Re: A Report by Newfoundland and Labrador Hydro (Hydro) pursuant to Order No. P.U. 22(2016) regarding the refurbishment of the gas generator engines at the Hardwoods Gas Turbine Plant and the Stephenville Gas Turbine Plant –Updated Report

Gas Turbine Failure Analysis Recommended Actions Implementation Update

A Report to the Board of Commissioners of Public Utilities

Drawing No: 183481: Air Start System

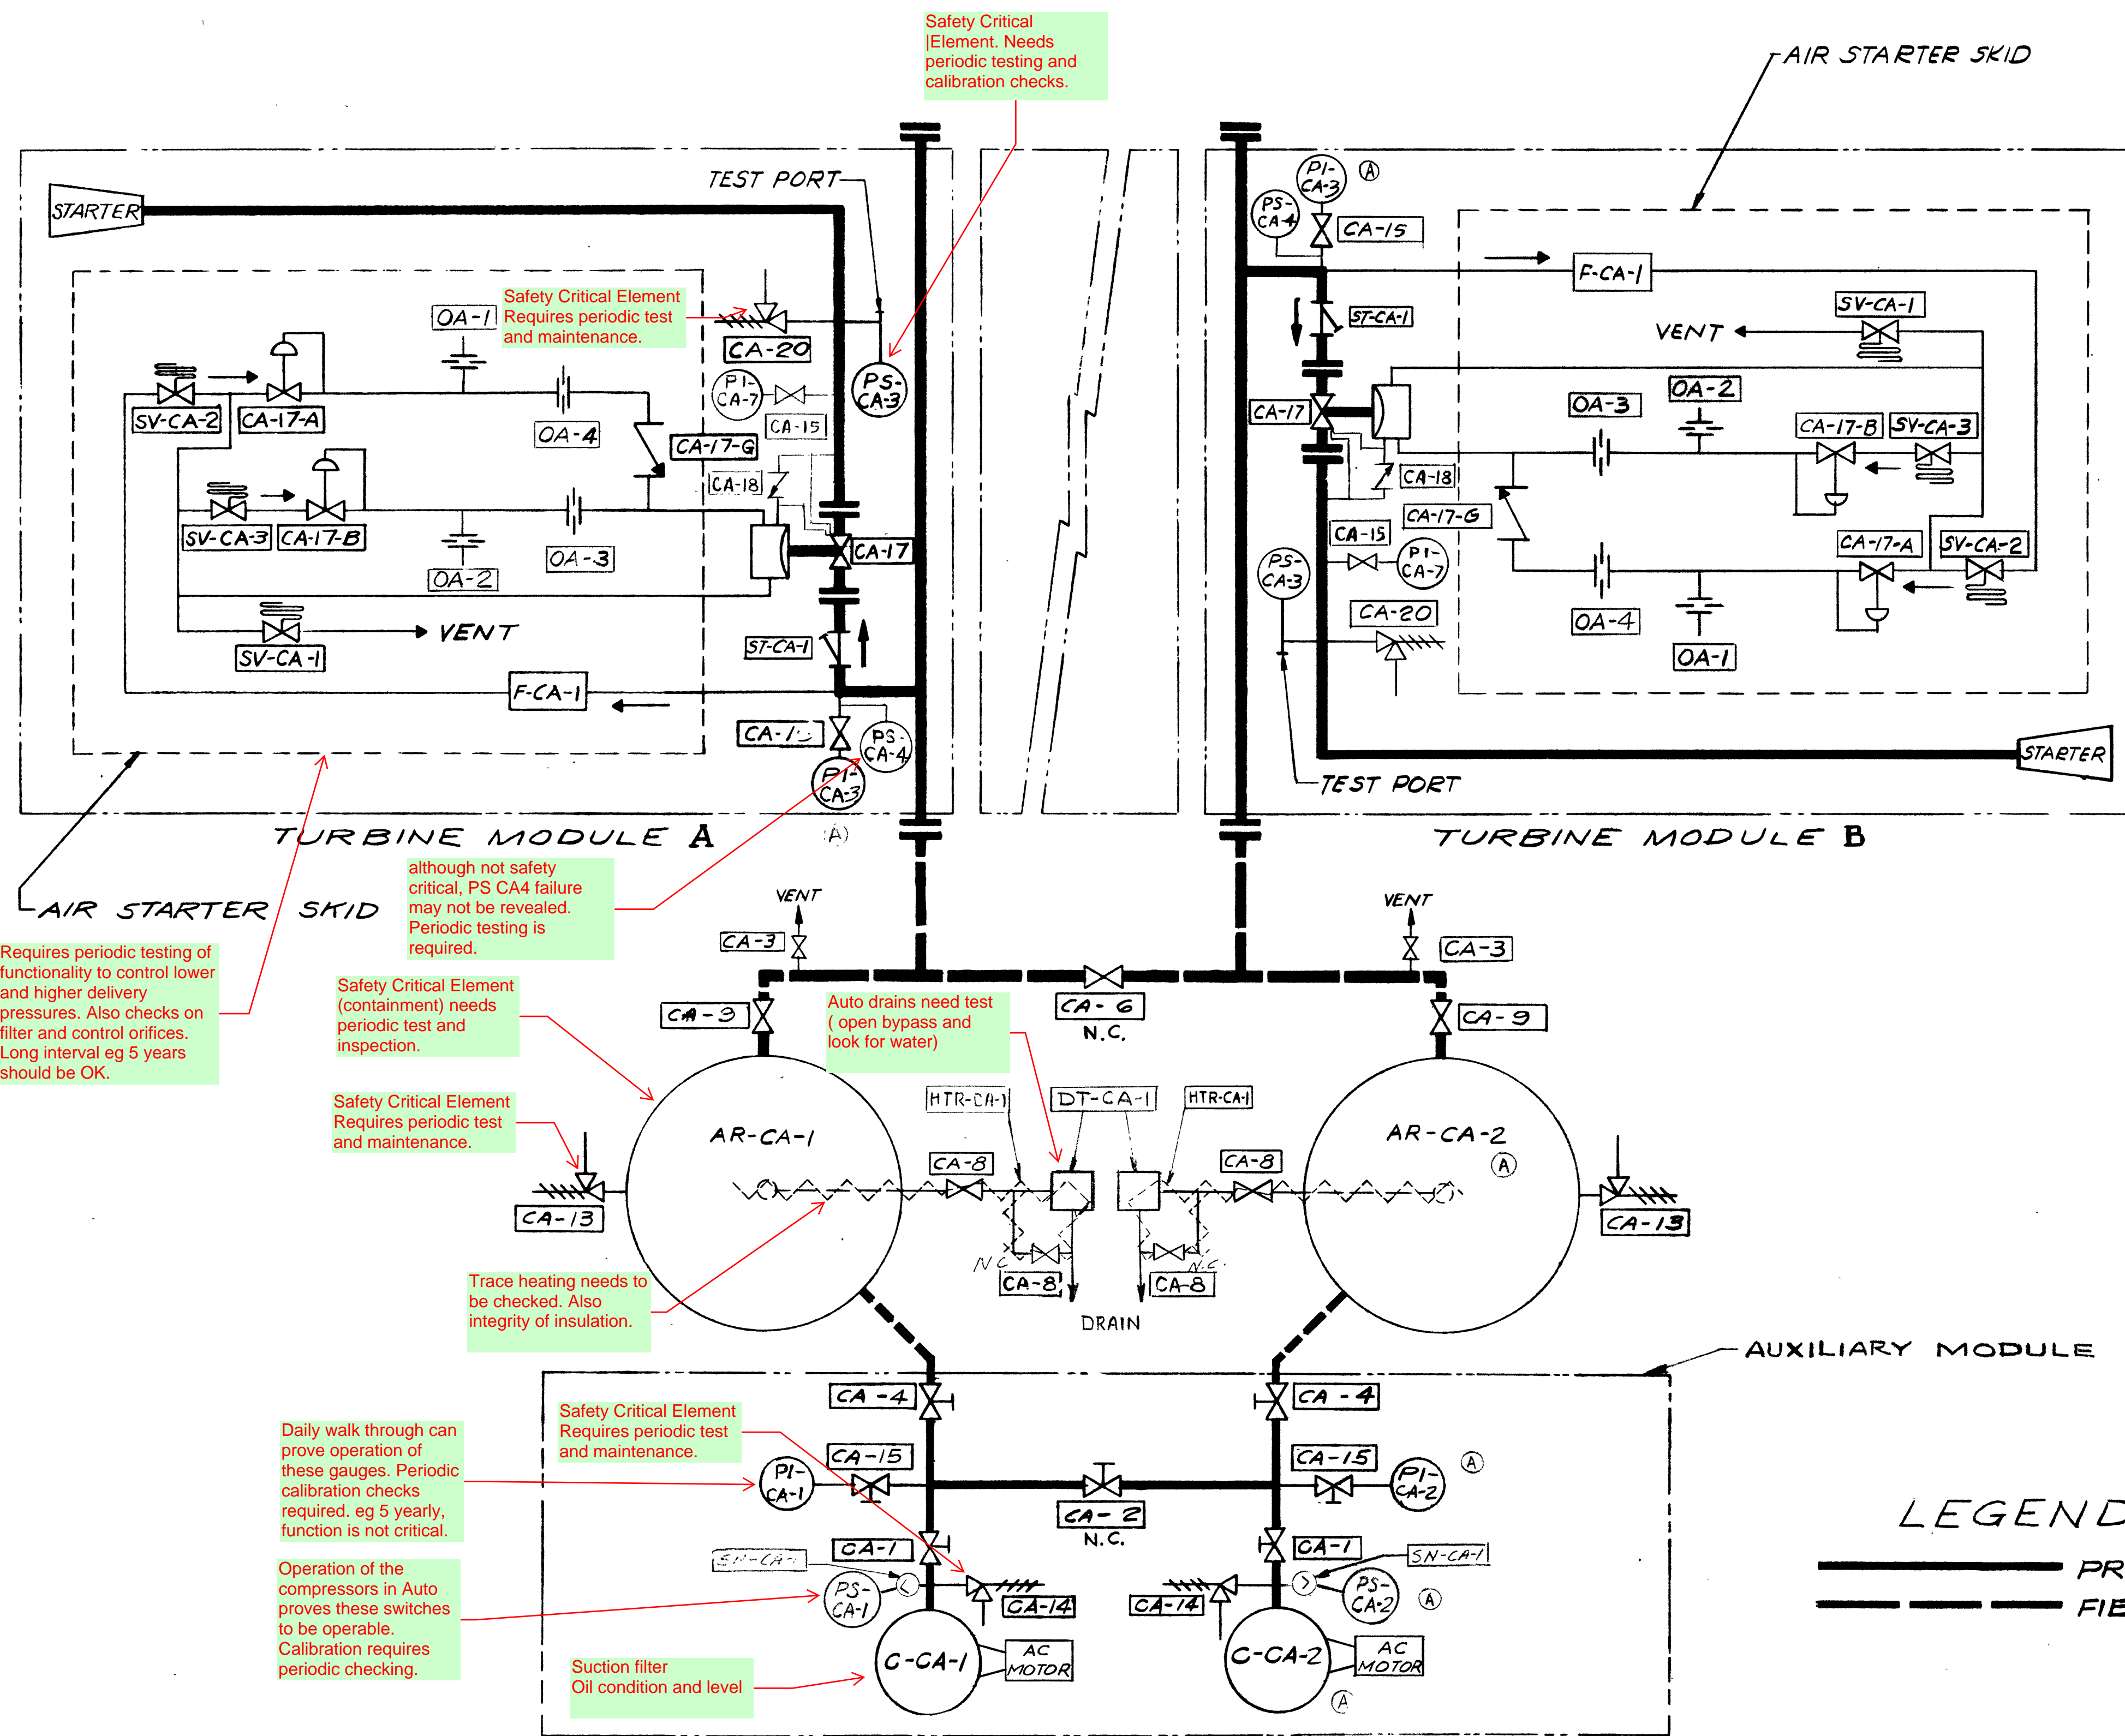
8. COMPRESSED AIR SYSTEM		Drawing 183481. CW manual 4 page 4-9 listss weekly checks.
a. Air leaks (lines safety valves, unloaders, etc.)		Marked drawing and /or checklist would ensure completeness and consistency.
